## FRANKLIN SERVICE BULLETIN

NO. 69

**SUBJECT:** CYLINDERS USED ON MODEL 6A4-150-B3 AND B31 ENGINES IN THE EARLY 11,000 SERIAL NUMBER SERIES ON STINSON AND BELLANCA INSTALLATIONS

EARLY TYPE

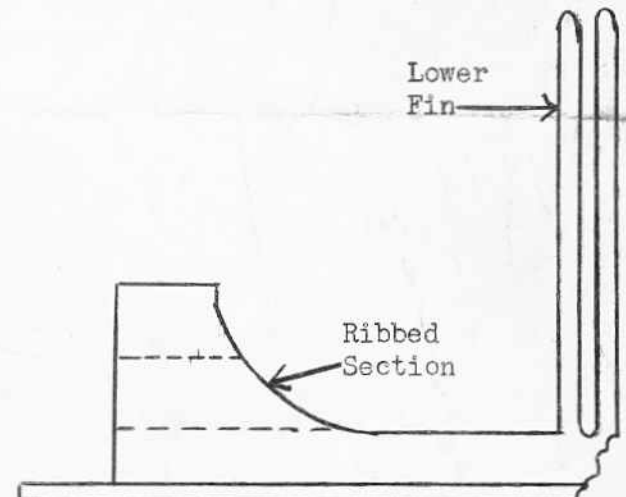
Examination of several cylinders indicates that cracks develop just above the base flange where the cylinder is bolted to the crankcase. Cracks are indicated in the thin wall section and also carry around the top section of the base flange in the pockets where the cylinder hold-down nuts are located.

This condition has been experienced only on the early engines which did not have the ribbed section below the fins extending out close to the outer section of the base flange itself. The ribbed sections are located in the area between the cylinder hold-down stud holes.

Note on early type cylinders the ribbed section stops abruptly at the base flange section facing toward the fins. The base flange section from that point to the outer edge of the flange is flat for a distance of approximately  $3/8$ " to  $7/16$ ", as shown.

Also, at top overhaul and major overhaul, or if for any other reason cylinders are removed, all early type cylinders must be replaced with late type.

It is mandatory that replacement of early type cylinders on engines in aircraft be made and visual inspection should be made for cracks every 25 hours until replacement is made.

LATE TYPE

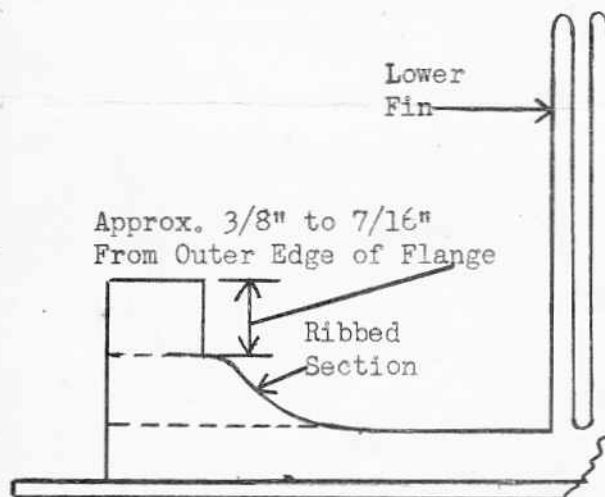
Note that on the late type the ribbed section carries out in a gradual radius close to the edge of the flange and the base flange does not have the 3/8" flat section, as mentioned previously.
